## **ARCHITECTURAL ADVISORY COMMITTEE MEMORANDUM**

SUBJECT: BRIAN FOSTER FOR A MINOR ARCHITECTURAL APPLICATION FOR REVISIONS TO THE FRONT ENTRY AT OLD LAS PALMAS ESTATES SUBDIVISION TO INCLUDE NEW LANDSCAPING, GATE, AND SIGNAGE, LOCATED AT LAS PALMAS ESTATES DRIVE, ZONE R-1-B. (CASE 3.4194 MAA) (GM)

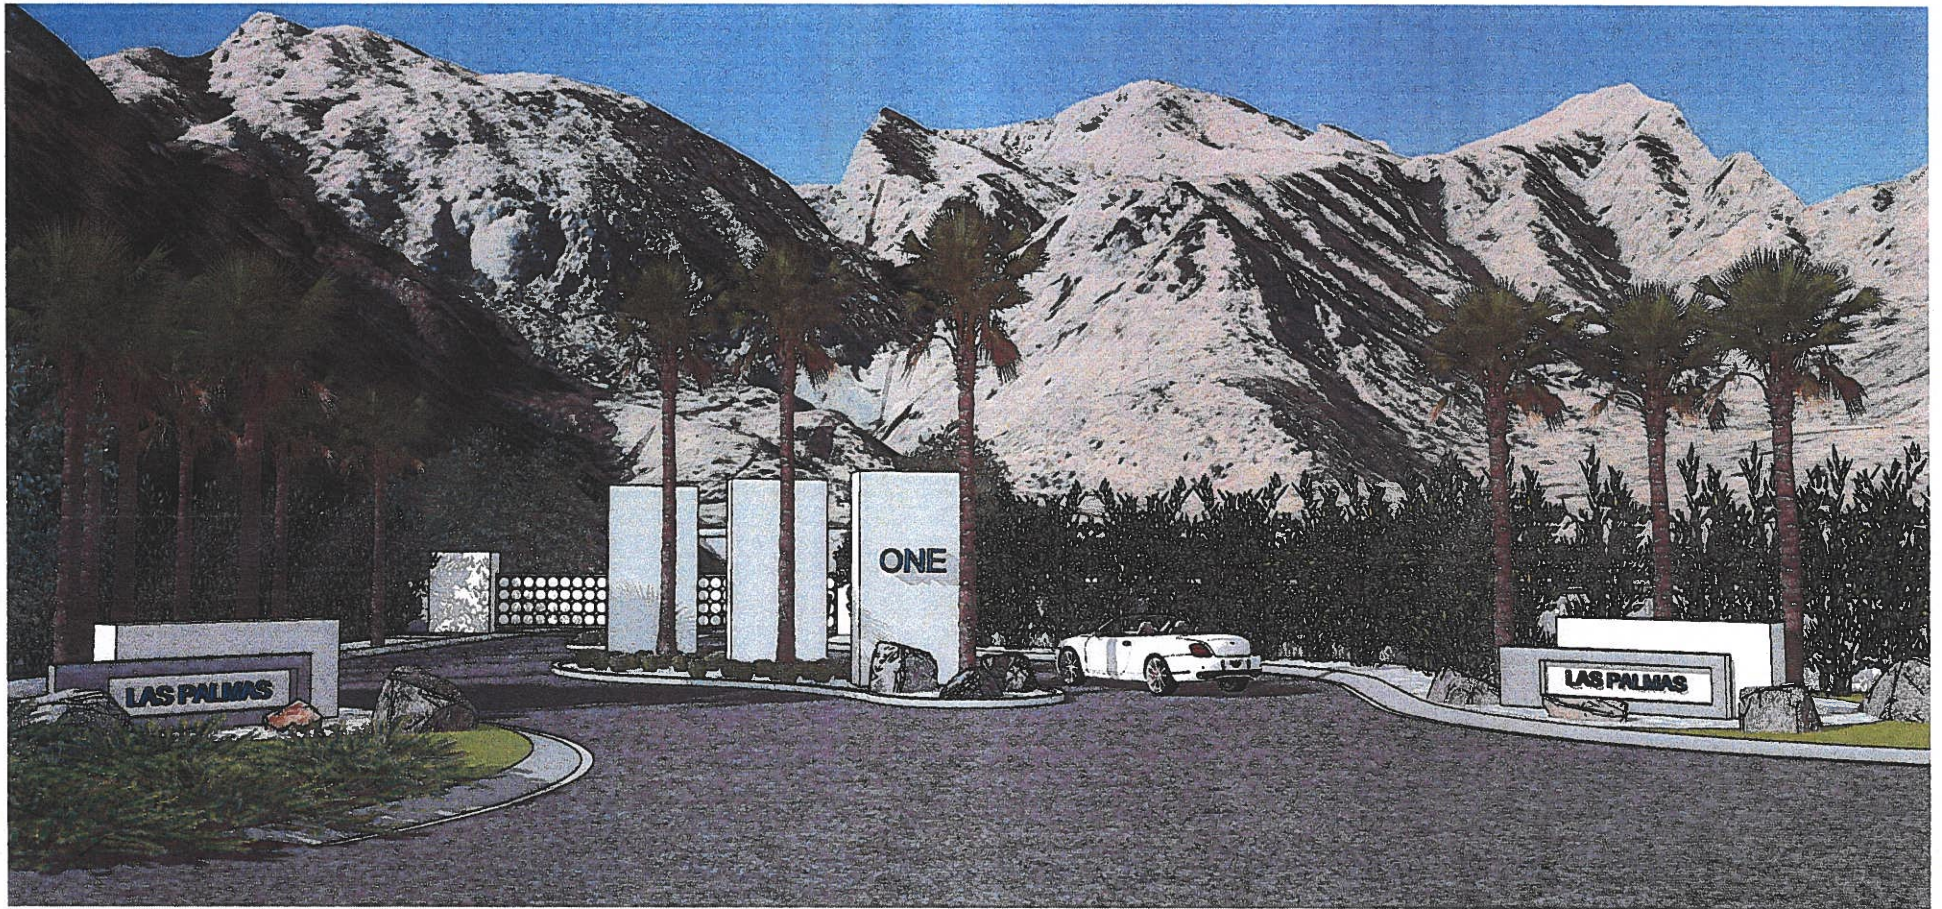
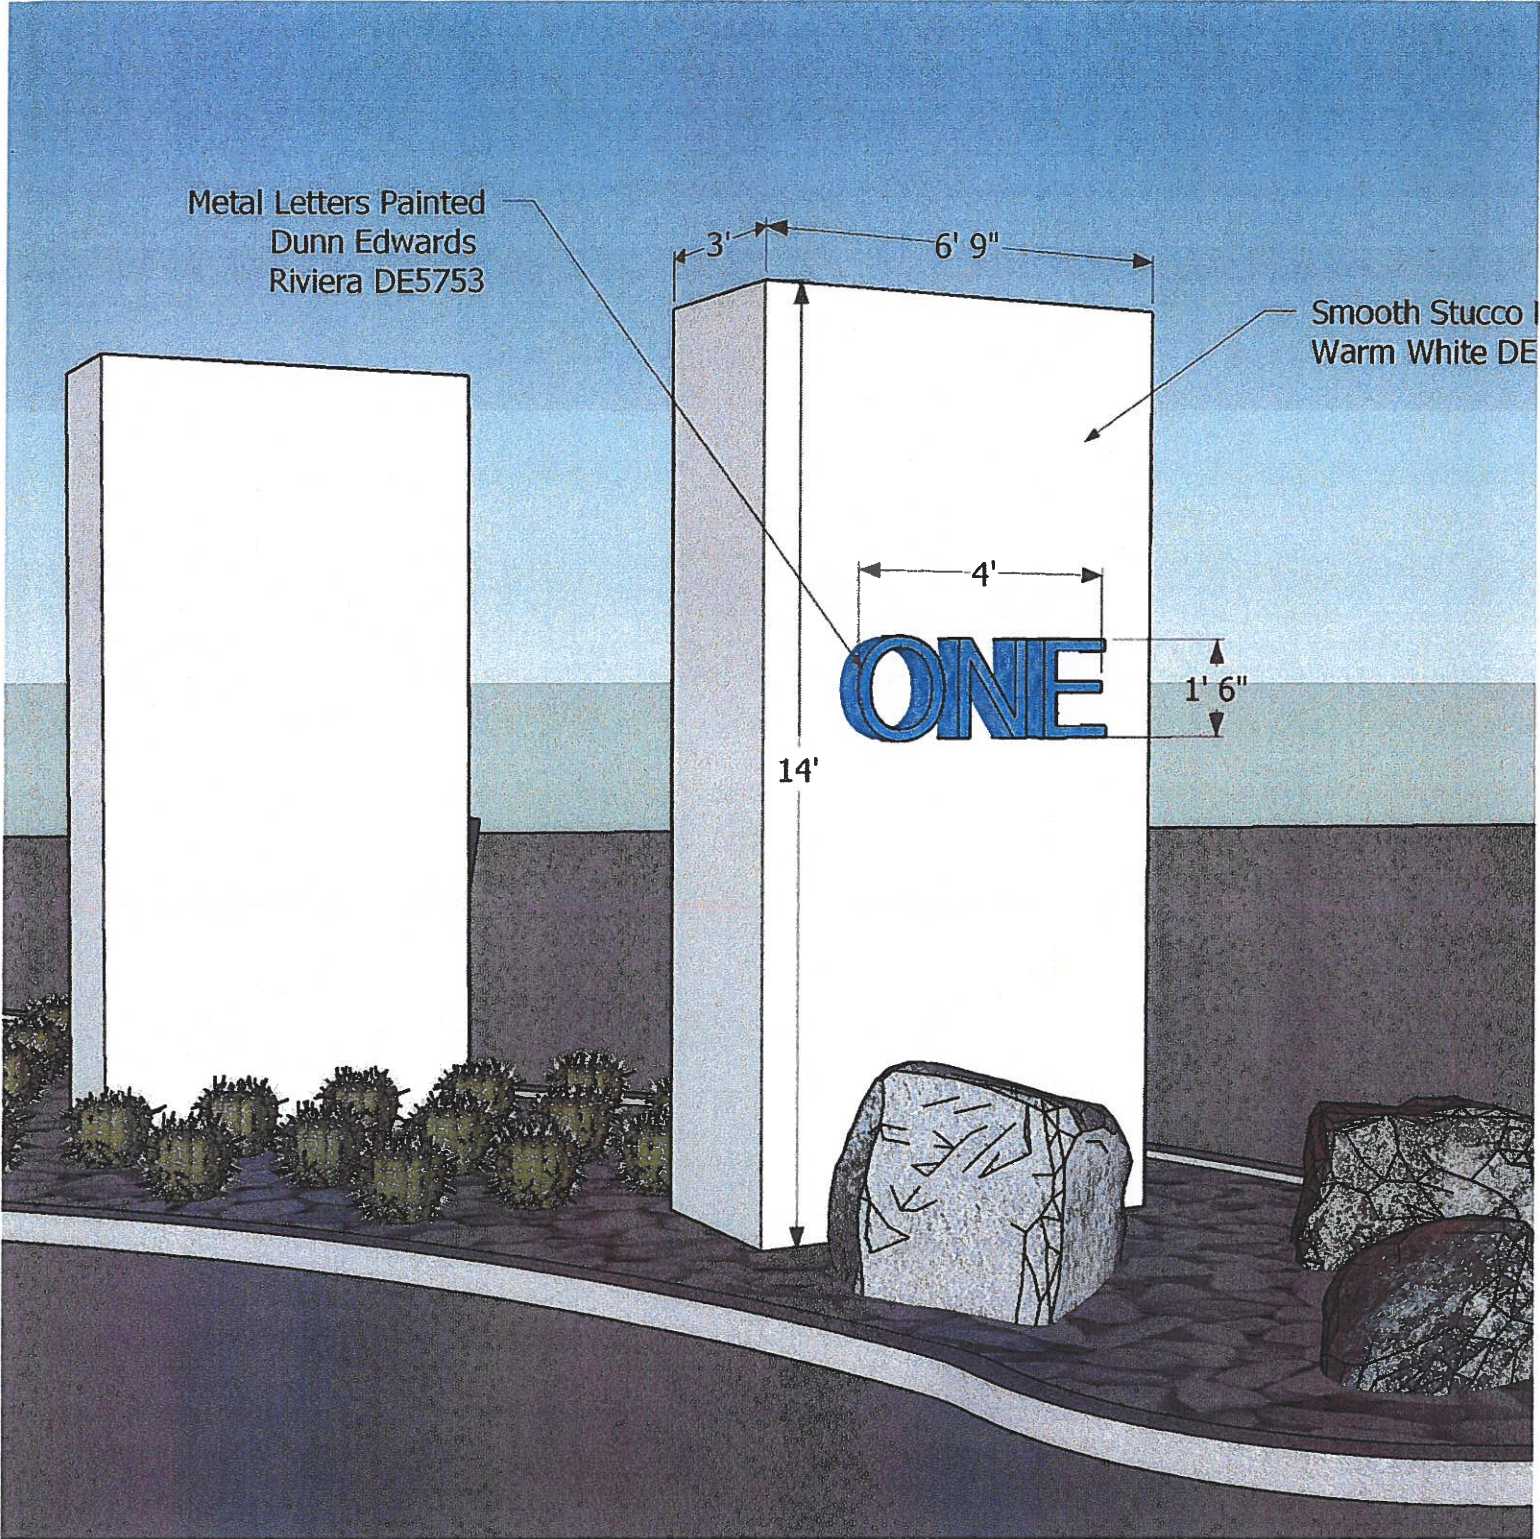
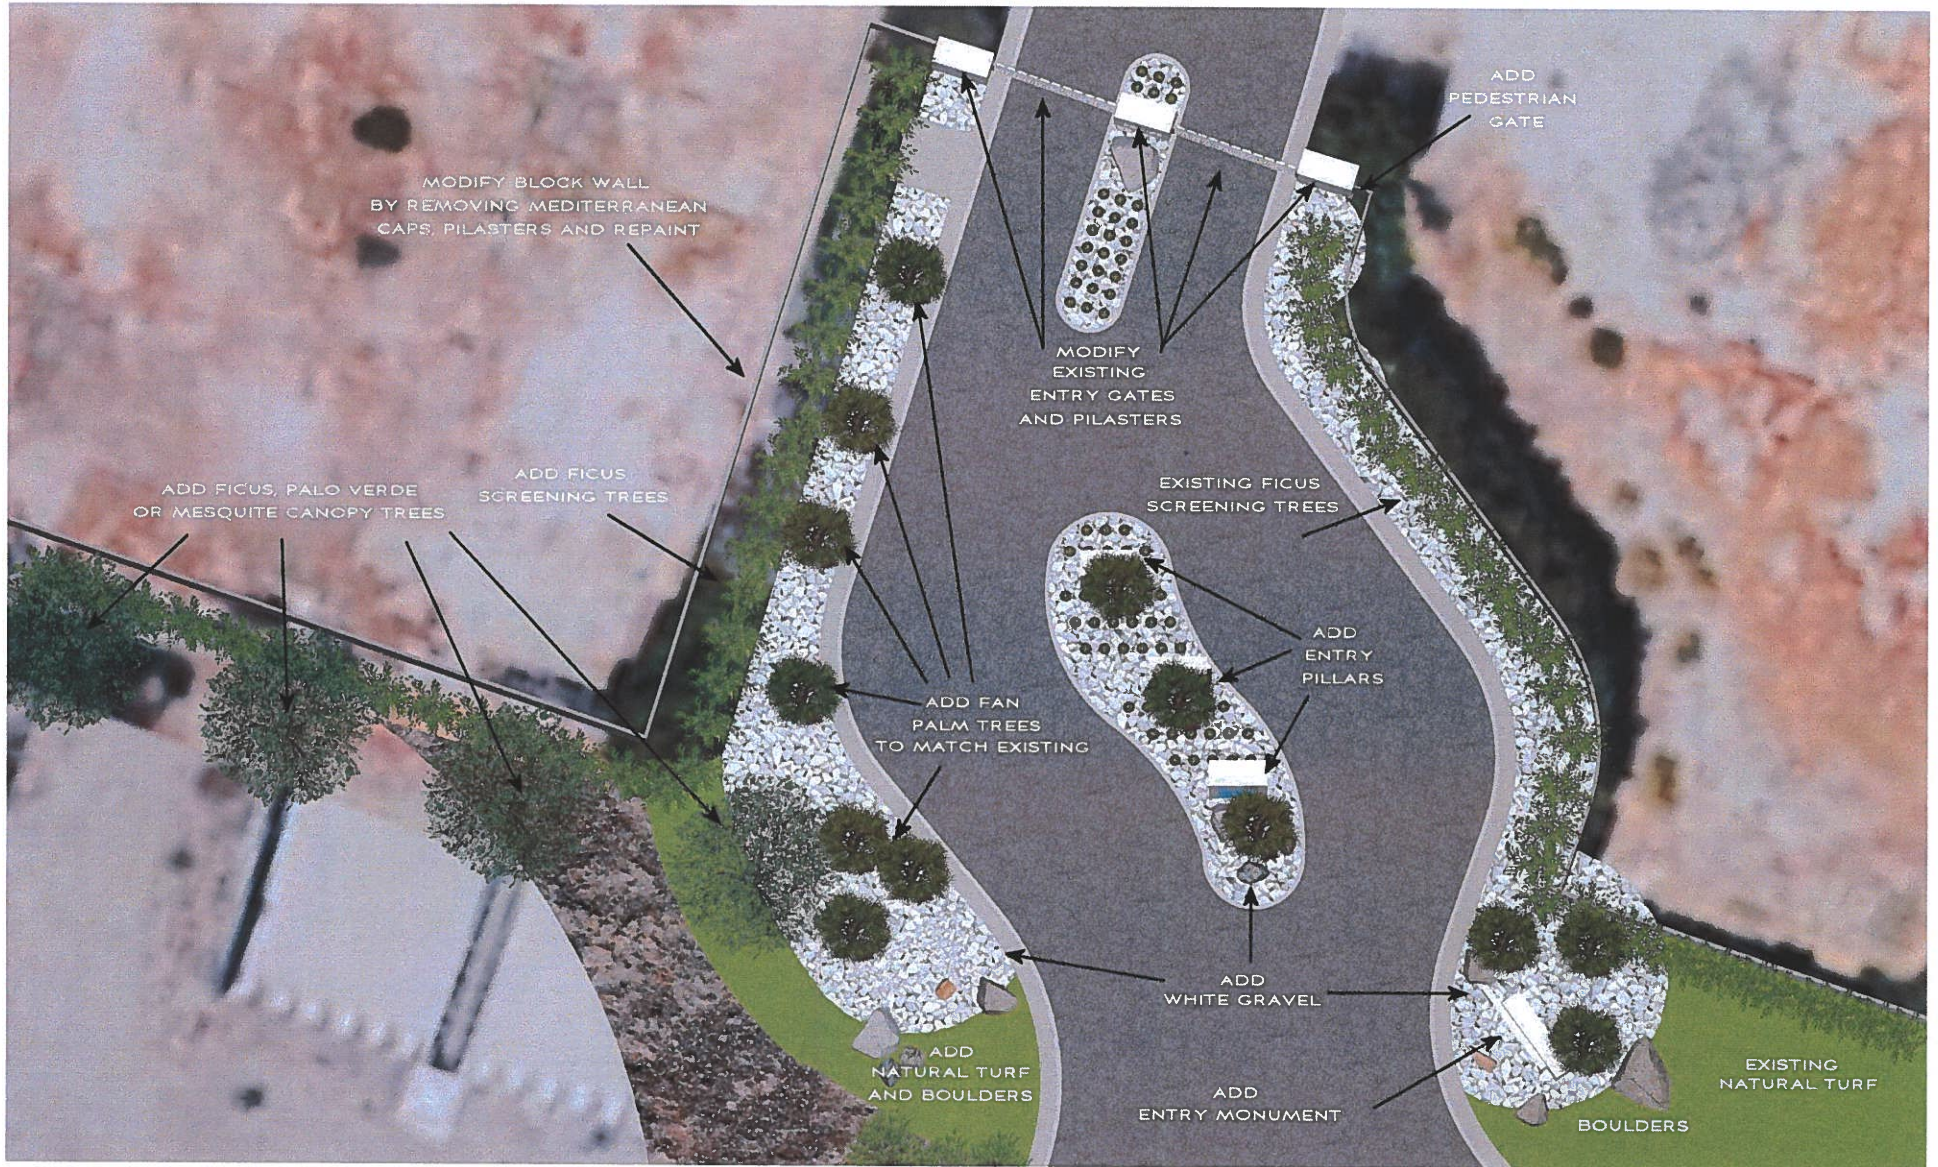
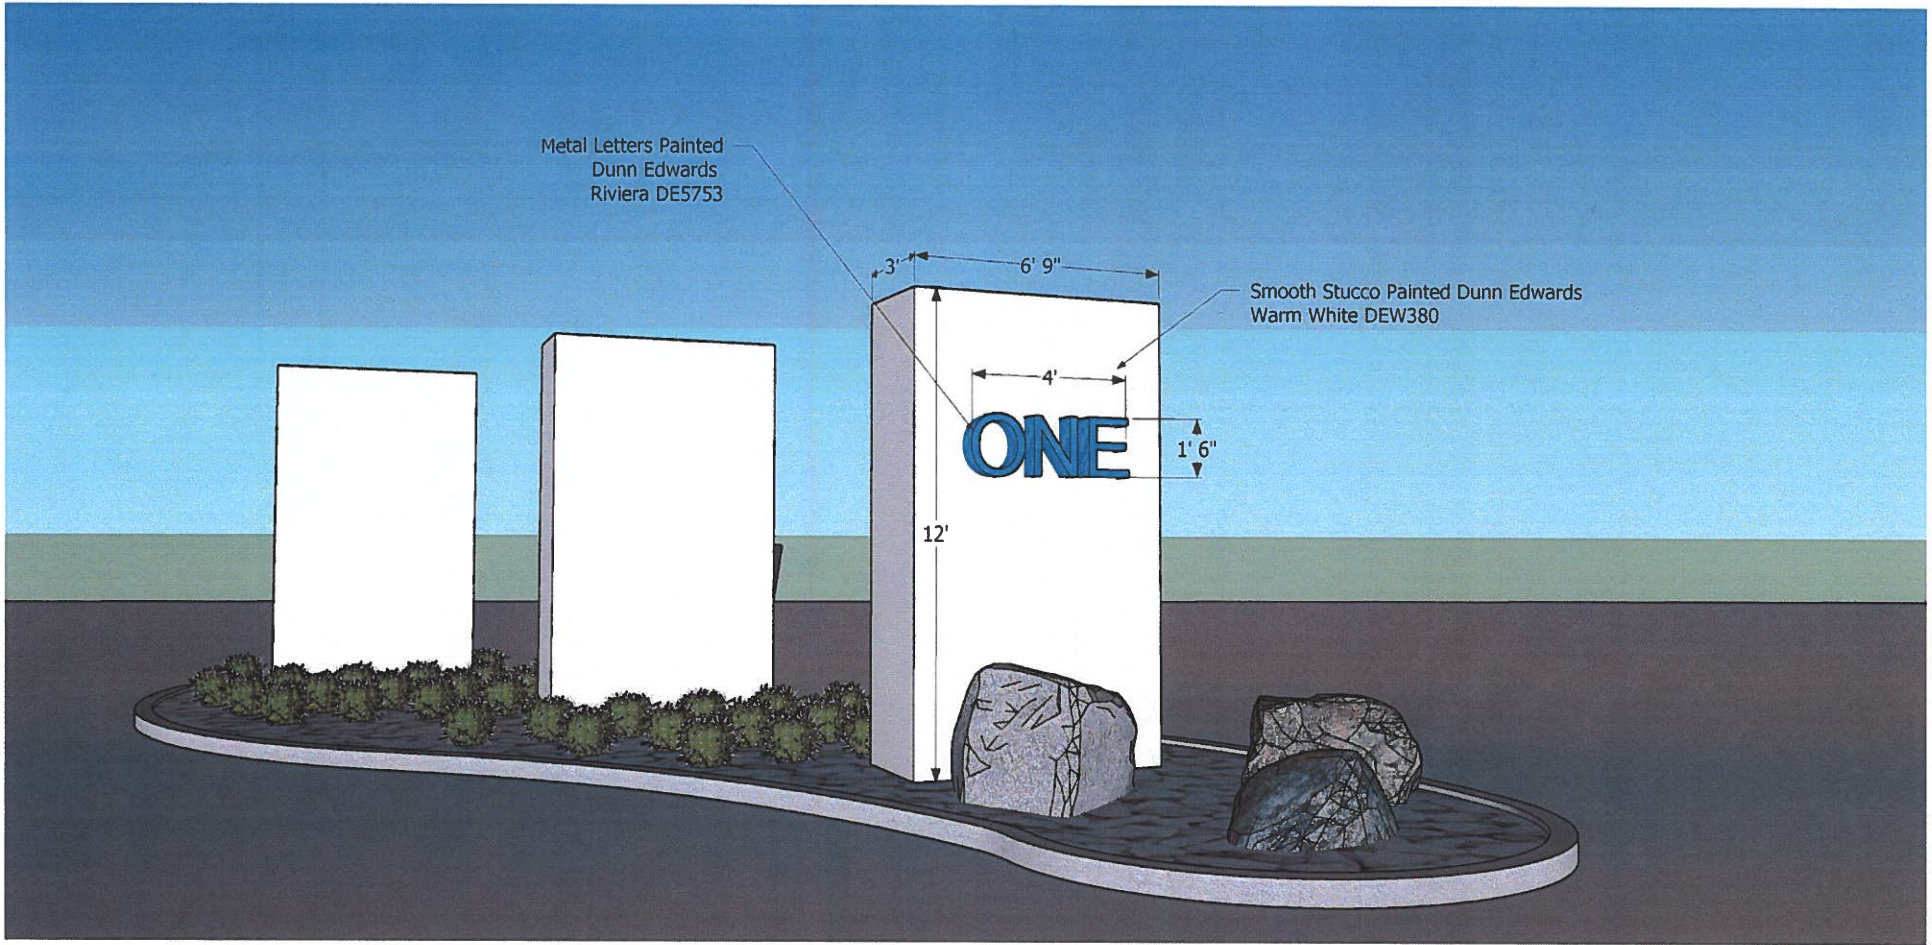
1. Add a pedestrian gate.
2. Lower the pillars to 12 feet.
3. Eliminate one monument sign.
4. Keep the existing berms.
5. Retain existing mature trees and boulders.
6. Consider using real turf instead of artificial turf.

1. Added a pedestrian gate on the right side of the vehicular gate.
2. Lowered the entry pillars from 14' to 12' feet.
3. One monument sign to be placed right of the entrance.

4. Existing landscaping to include berms, trees and boulders to remain.
6. The applicant prefers to use artificial turf, however is open to use real grass.
